Service Bulletin SB.JS-014

5 July 2012

Clevis Pins and Split Pins in Canopy Release Mechanism

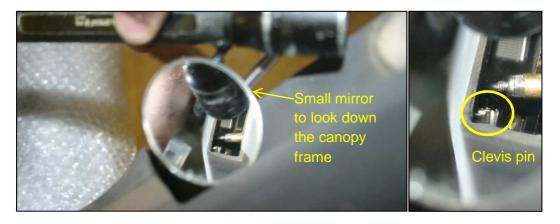
- 1. Remove the canopy from the glider, and place on two stands to allow access from below. Leave the release and jettison handles fully opened.
- 2. Using a torch light, inspect the canopy jettison rod at the front to see the Clevis pin and split pin.

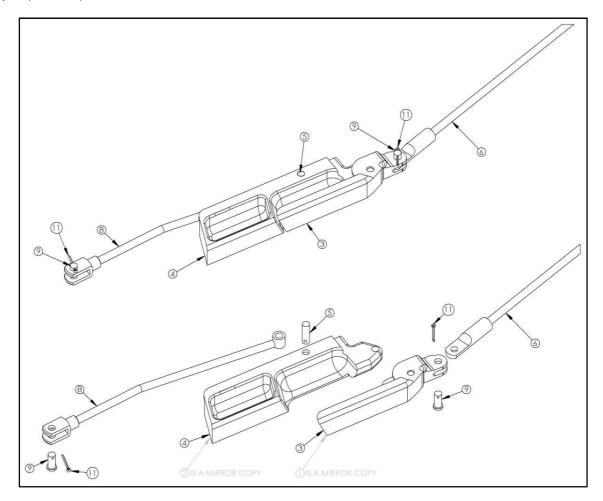
Both Clevis pins (Item 9) must be installed from below and each must be secured by a split pin (Item 11).

If either split pin is missing, or appears to be slipping out, replace it immediately.
